Access Compliance Report Public Rights-of-Way (Curb Ramps)

Main Street: COPA_DE_ORO_DR Cross Street: MONTECITO_RD Location: NW

ADA ID: RPRK211206180251 Ramp Type: Type 4 - Parallel Initial Pass/Fail: Fail Overall Compliance: No Severity Score: 15

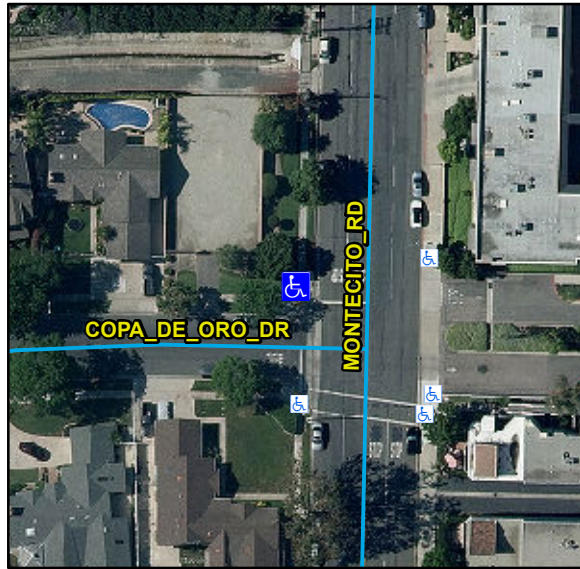
Compliance	Description	Data	Compliance	Description	Data
N/A	Ramp Length LT (in)	83	N/A	Ramp Length RT (in)	83
Yes	Ramp Width LT (in)	106	Yes	Ramp Width RT (in)	106
Yes	Ramp Run Slope LT (%)	6	Yes	Ramp Run Slope RT (%)	6.5
No	Ramp Cross Slope LT (%)	2.1	No	Ramp Cross Slope RT (%)	6.8
N/A	Landing Present	N/A	N/A	DWS Provided	N/A
N/A	Landing Length (in)	N/A	N/A	DWS Contrast	N/A
N/A	Landing Width (in)	N/A	N/A	DWS Length (in)	N/A
N/A	Landing Run Slope (%)	N/A	N/A	DWS Full Width	N/A
N/A	Landing Cross Slope (%)	N/A		DWS Offset Type	N/A
N/A	Landing Movement Obstructed?	N/A	N/A	DWS Offset Left (in)	N/A
	Landing Movement Type	N/A	N/A	DWS Offset Right (in)	N/A
N/A	Landing Shared	N/A			
N/A	Clear Space	Yes			
N/A	Clear Space To Crosswalk (in)	N/A			
N/A	Marked Crosswalk 1	No	N/A	Marked Crosswalk 2	No
	Crossing 1 Direction	S		Crossing 2 Direction	E
	Marked Crosswalk 1 Width (in)	N/A		Marked Crosswalk 2 Width (in)	N/A
N/A	Ramp Inside Crosswalk 1	N/A	N/A	Ramp Inside Crosswalk 2	N/A

Remove & Replace Curb Ramp With Two New Directional Ramps or Equivalent.

R304.5.3, STD 1115
